This software updates or alters the functions and features noted below. The instructions and information that follow are meant as a supplement to the original instruction manual that accompanied the T18SZ/T16SZ/FX-36 transmitter. Please refer to the original instruction manual where applicable, but replace the steps indicated below with these instructions. Please check to ensure that the update has been installed.

This software updates or alters the functions and features noted below. The instructions and information that follow are meant as a supplement to the original instruction manual that accompanied the T16SZ transmitter. Please refer to the original instruction manual where applicable, but replace the steps indicated below with these instructions. Please check to ensure that the update has been installed.

### 4. Data Converter

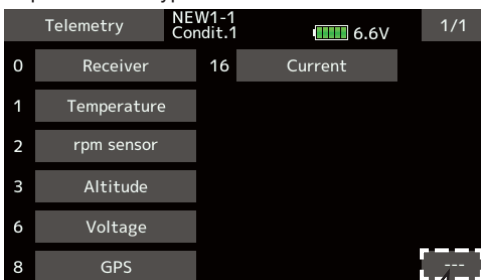
FX-30 and T12FG have been added to the data converter compatible models.

The transmitter name is displayed on icon.

### 5. Butterfly Elevator setting (Glider)

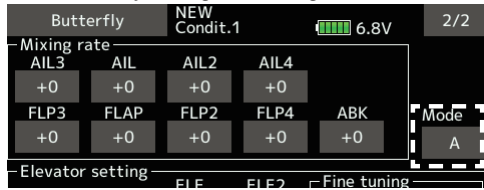
Added fine tuning function to butterfly elevator setting.

\*When Flying wing type, it was made not to display Elevator setting.

### • Mode A

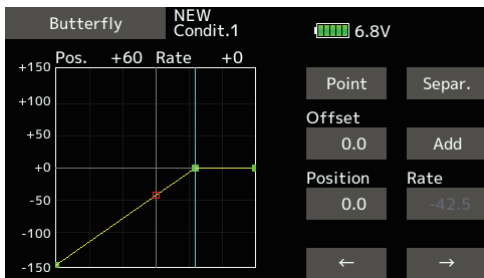
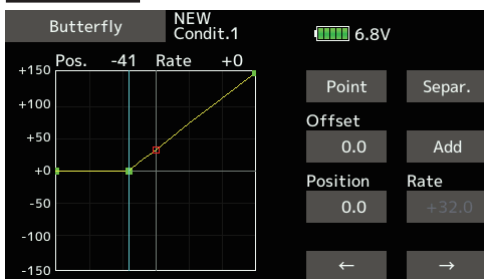
(Normal)

- The butterfly operation direction is reversed at the neutral position (50%) of the throttle stick.

At offset 20

At offset 70

The direction of butterfly motion is reversed.

### • Mode B

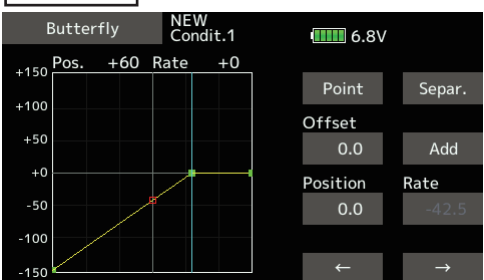
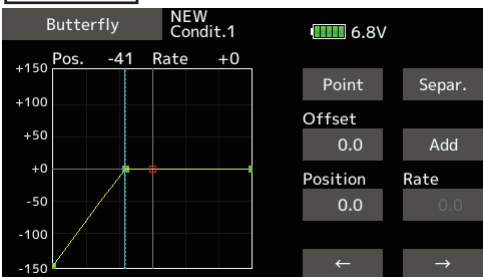
(Throttle stick full stroke MODE)

- It does not reverse at the neutral position, so you can set the butterfly operation start point with the full stroke of the throttle stick.

At offset 20

At offset 70

The direction of butterfly motion is not reversed.
